Thor Motor Coach Recall Repair Instructions

Recall #	23v-759 & 2023-621		
Description/Title:	Rize and Scope Solar Panels		
Affected Product Line(s):	Certain model year 2021 – 2024 Rize and Scope motorhomes		
Service Campaign # :	RC000298	Released Date:	1/10/2024
Repair Code:	Inspect: TMCRC80511Y Repair: TMCRC80511V	Document Date:	1/9/2024
Time Allowed:	Inspection .2 Repair .5	Document Revision:	A

FIGURE 4-A: SOLAR PANEL INSTALLATION DETAILS

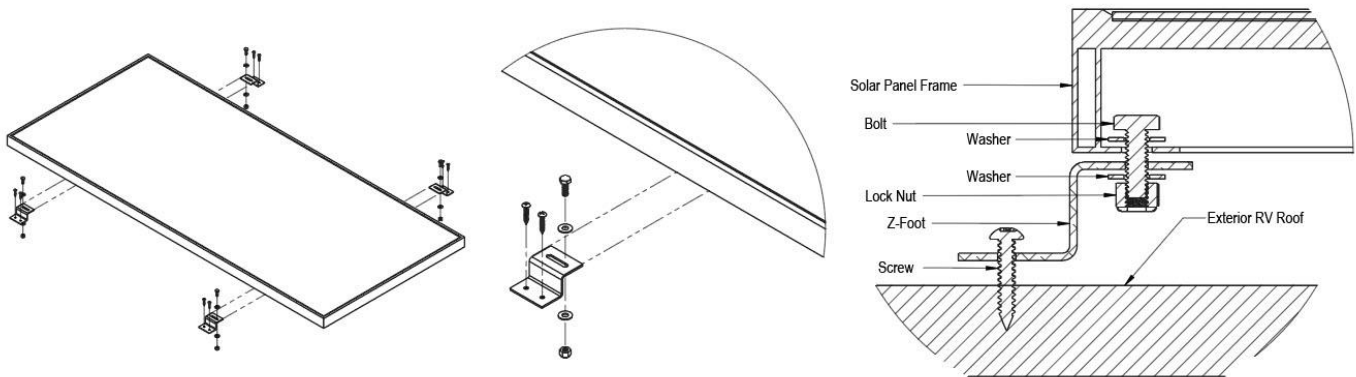
It has been discovered that on certain model year 2021 – 2024 Rize and Scope motorhomes that the solar panel mounts may fracture. The hardware used to mount the solar panel to the roof brackets may be missing the washers on the bolts at each of the four brackets.

1. If the aluminum frame does not show signs of fracture, two washers are to be installed at each of the four brackets as shown in Fig. 4-A
2. If the solar panel does show signs of fracture, replace the panel, as well as add the washers to the hardware. You will need to determine if you have a 190 watt or 200 watt solar panel and order through Thor Motor Coach’s parts department.
